To: INCITS Technical Committee T10
From: Fred Knight, Network Appliance
Email: knight@netapp.com
Date: 8 January, 2009
Subject: SBC-3 Thin Provisioning Commands

Proposal:

Figure B – Logical Block State Transitions

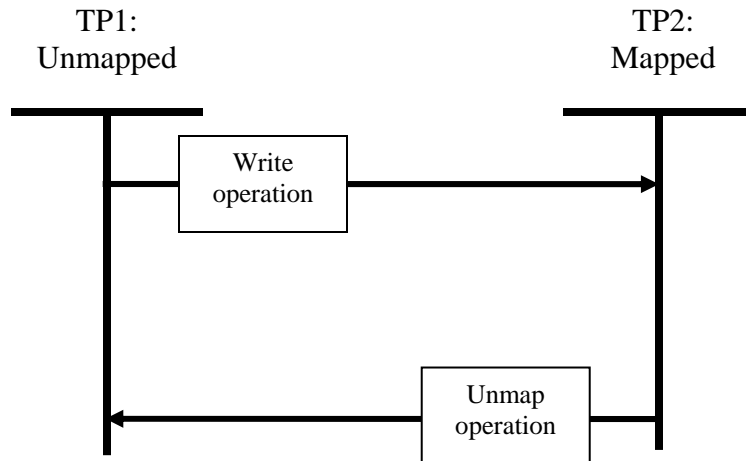
Transitions between the mapped and unmapped state are shown in figure B.

4.4.1.2.1 Transition TP2:Mapped state to TP1:Unmapped state

This transition occurs when an unmap operation completes without error (see 4.4.1.5.2). As a result of this transition, the user data retrieved by the next read operation ~~or verify operation~~ may be indeterminate (see TPRZ bit in READ CAPACITY(16) parameter data (6.4.3) and UNMAP command (5.x)).

4.4.1.3.1 Transition TP1:Unmapped state to TP2:Mapped state

- a) shall occur when a write operation occurs. As part of processing a write operation, the device server may cause LBAs other than those specified by that write operation to transition from unmapped state to mapped state; or
- b) may occur at any other time for vendor specific reasons.
